Re : Non-destructive examination of Touchtone 12 -
PWB and component mounting

Examination of PWB for Touchtone 12 reveals the following shortcomings:

Figure 1

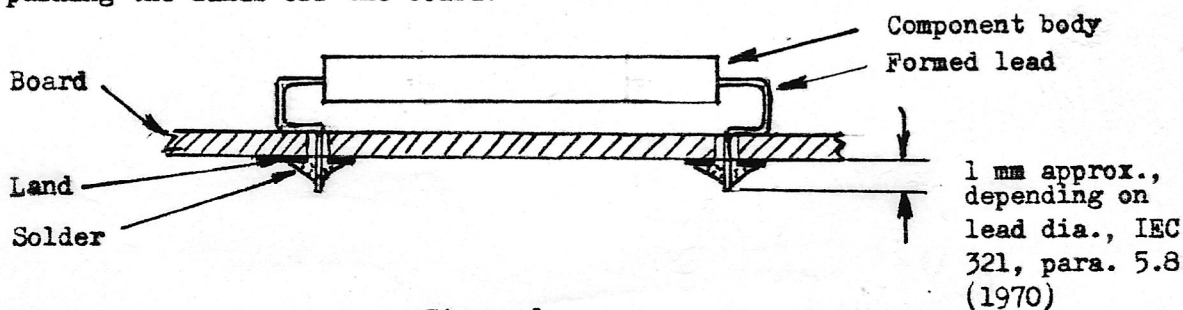
- 2.2 On the solder side of the board, the component leads and connecting wires protrude too far above the surface (Photo No. 5, Items 1, 2, 3 and Fig. 1).
- 2.3 Glass encapsulated diode should have at least one of the leads formed into a loop (See Fig. 2) to prevent breaking of the seals between the glass and the leads during thermal expansion and contraction. None of the glass encapsulated diodes have their leads properly formed. (Photo No. 9, Item 1).

- 1.4 Solder flux on the board has not been cleaned (Photo No.3, Items 9 - 11, Photo No.7, Items 1 & 2 and other areas too numerous to mark).
2. Attempt to mount components on the board properly has been carried out but not effectively. In a well designed and well assembled board the components are stood off the board to prevent moisture being trapped under the body of the component. Components with axial leads usually have the leads formed as shown in Figure 1, to stand the body off the board and also to prevent accidental pressure on the component from pushing the lands off the board.
